**ADDENDUM TO THE
SPECIALIST IMPACT ASSESSMENT FOR PROPOSED
SPRINGBOK WIND ENERGY FACILITY, NORTHERN
CAPE: VEGETATION COMPONENT.**

**Prepared for: Holland & Associates Environmental Consultants,
Tokai**

Client: Mulilo Springbok Wind Power (Pty) Ltd., Cape Town

16 Oct 2017

Figure 3: Google Earth image of northern part of the proposed layout superimposed on the botanical sensitivity map. All unshaded areas are of Medium or High botanical sensitivity.

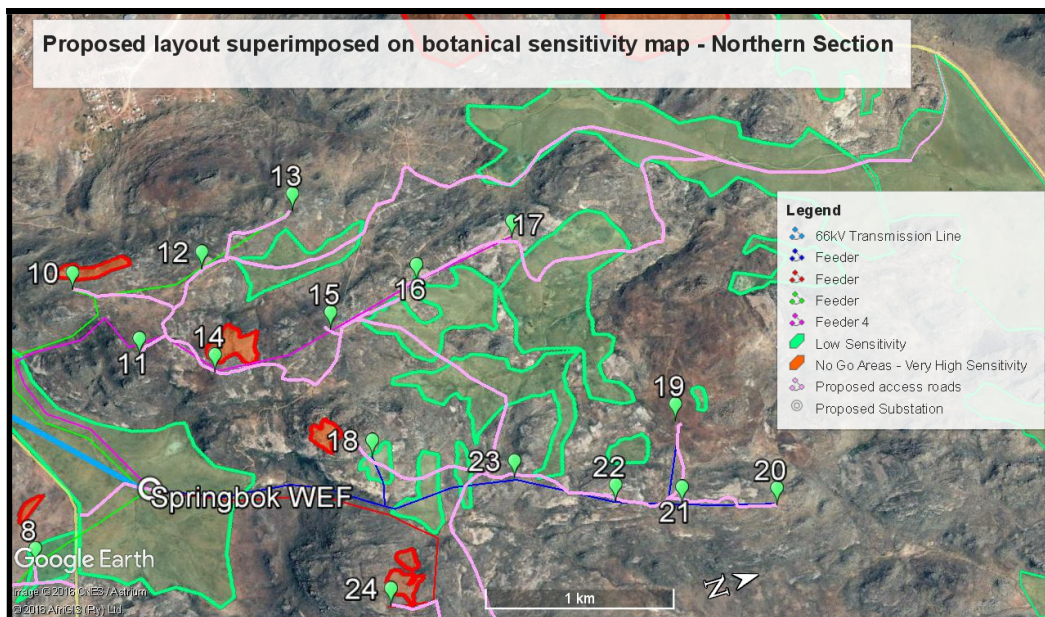
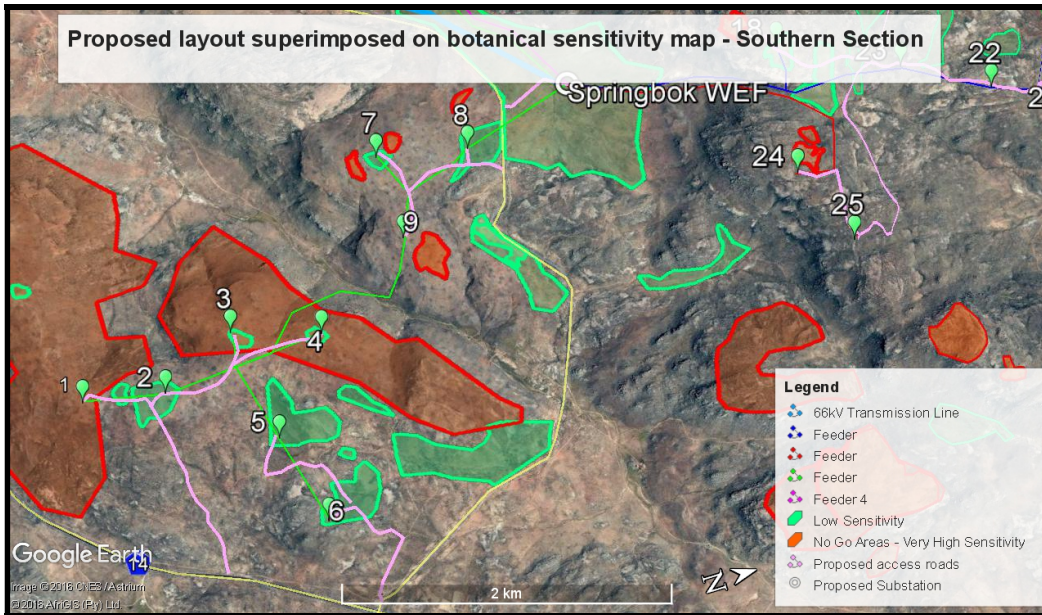
Infrastructure that will be located within Very High sensitivity areas include Turbine 1, part of the road between Turbines 3 & 4, and short parts of the road to Turbines 14 & 24.

- Construction operations in all areas other than mapped Low sensitivity areas (see Figures 3 & 4) should be restricted to the dry season (15 October to 1 May) to minimise damage to seasonal plants such as bulbs.

- Turbine 1 should be moved at least 80m east, out of the Very High sensitivity area. This new position would be at the same altitude and

would still be more than 360m from Turbine 2, and is unlikely to compromise its efficiency.

Figure 5: Extract of the Namakwa District Critical Biodiversity Area (CBA) map, overlaid with the proposed, amended layout. Overlapping green polygons are due to the different reasons for selection of the areas as CBAs.

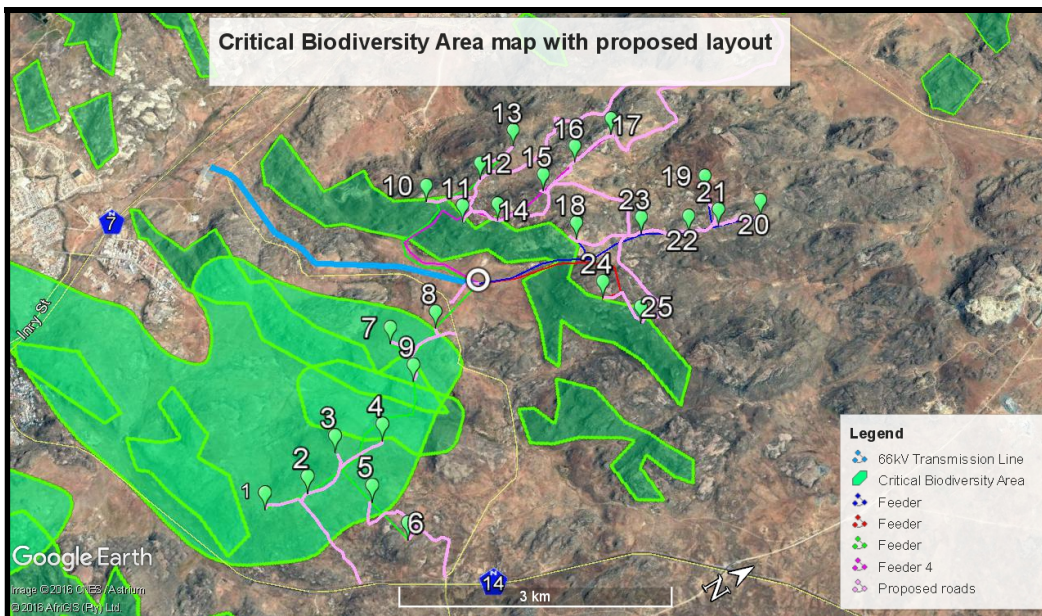
The presence of about eleven proposed turbines and associated infrastructure (both Alternatives) within the mapped Critical Biodiversity Area on the site is of concern, and is one of the primary reasons for the minimum Medium negative significance rating. An appropriate biodiversity offset which supports and increases a nearby formal conservation area is the only mitigation that could reduce this particular impact (other than layout redesign).
